# Annual Fire Safety Engineer (FSE) Dialogue Session

Monday 12<sup>th</sup> March 2018

SCDF HQ

# Examples : Good (But not all good)

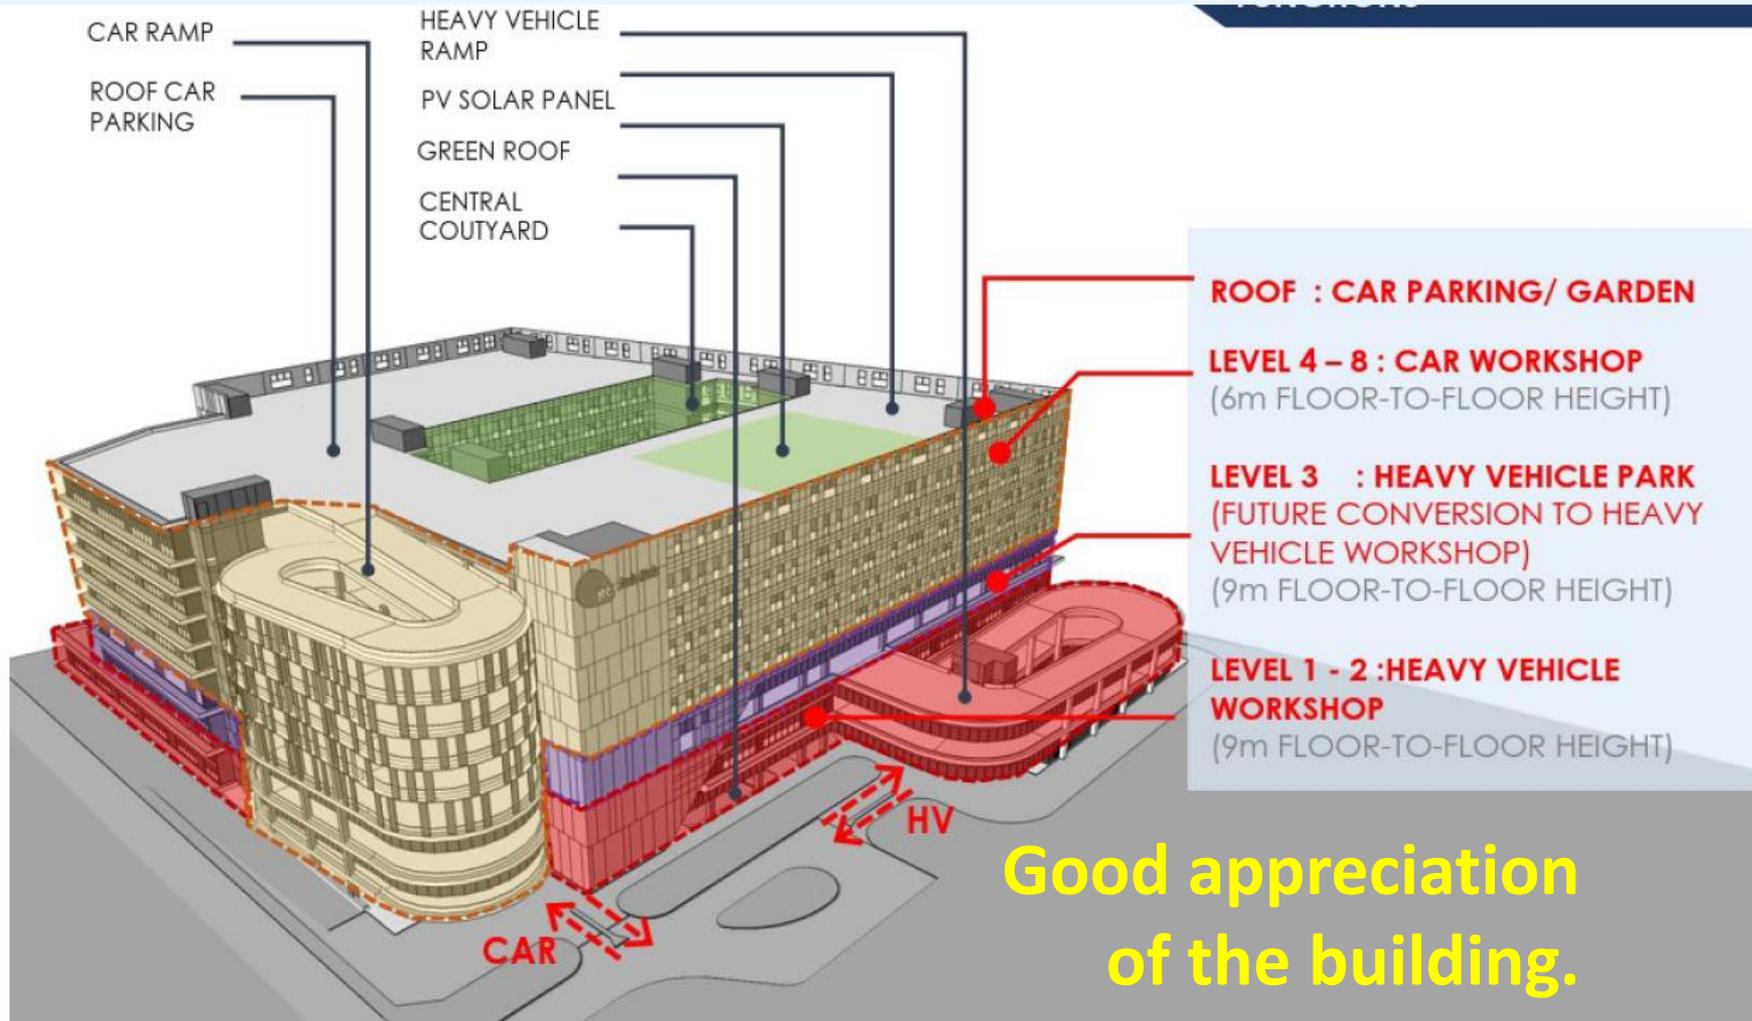
**Important info needs to  
be clearly seen and vice-  
versa.**

Good : Use of colours.

Bad : Why underline everything ?

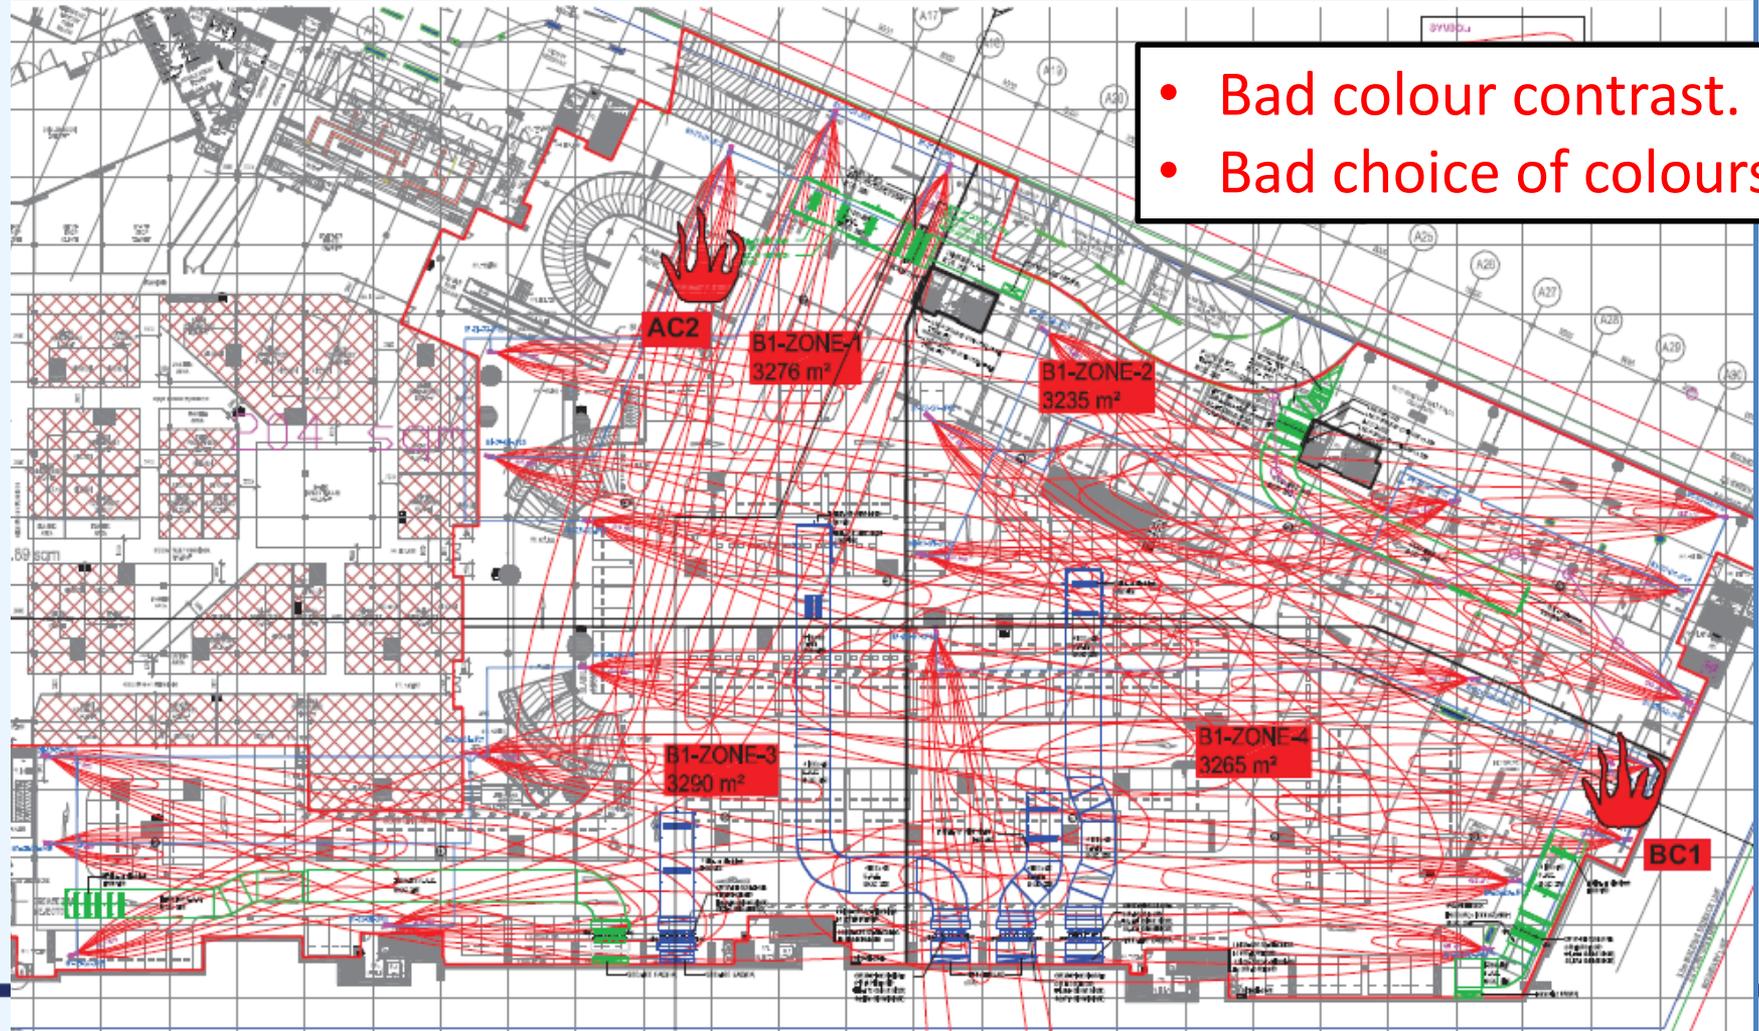
## Standardise :

Comma / No-comma.

LOWER 1ST STOREY PLAN

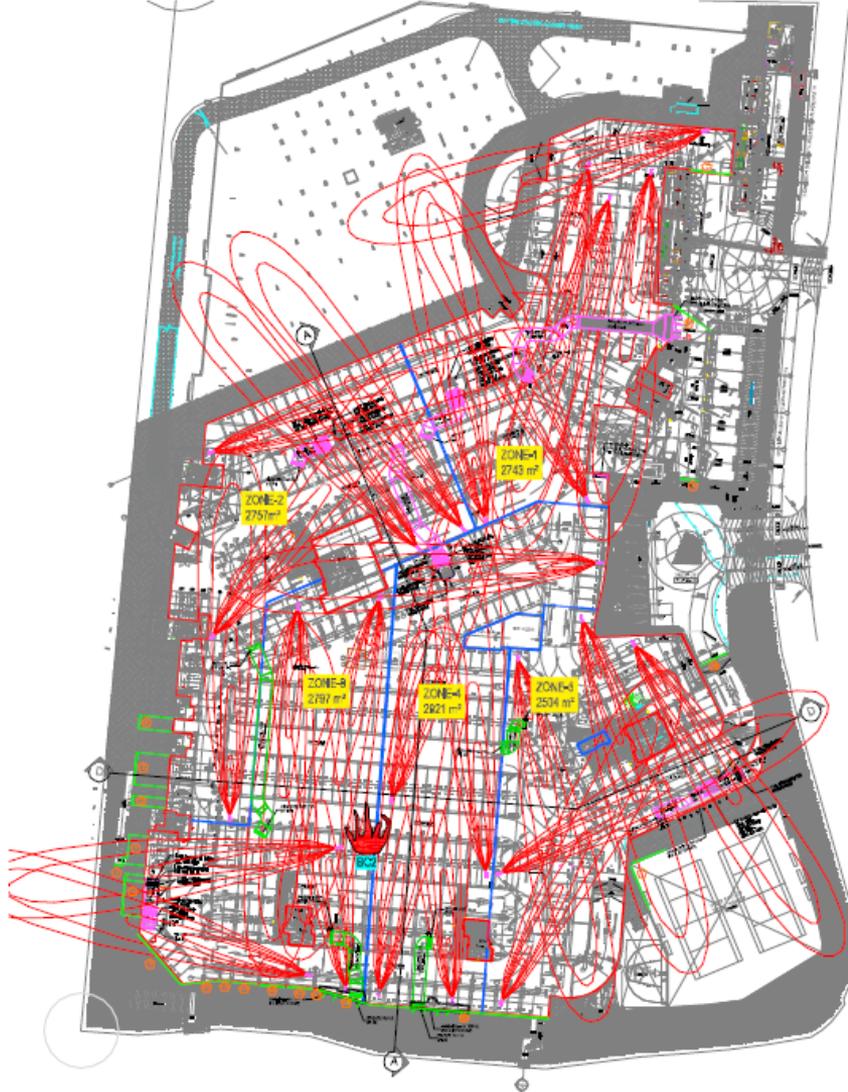
*Really ????*

## Radiant Heat Assessment – Scenario RS 1 @ 1MW Fire: CFD Simulation Slices

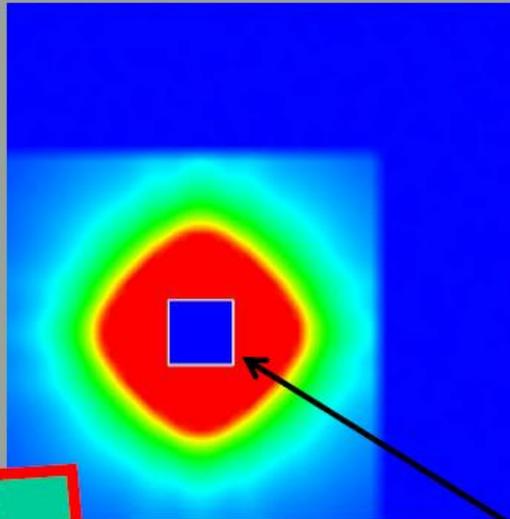
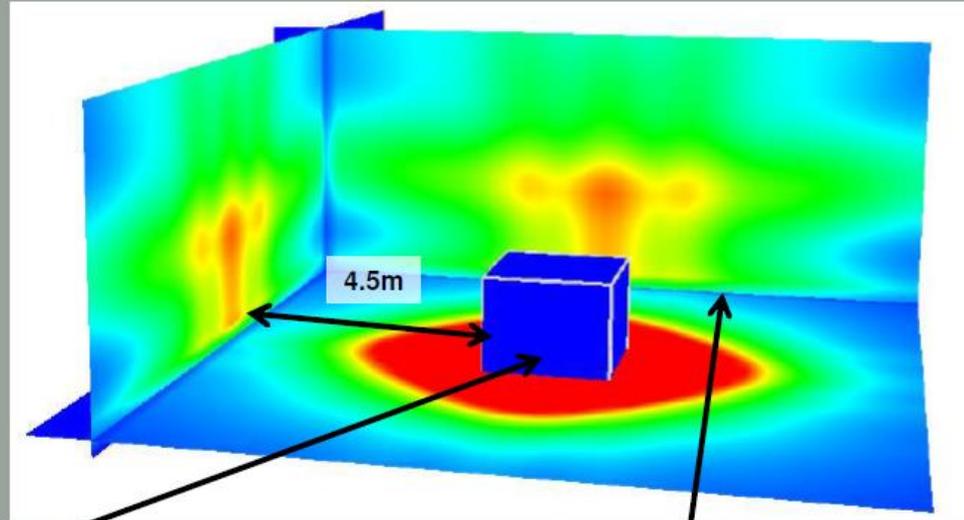
Something critical is missing from these following three slides??  
[Don't let us guess/assume.]
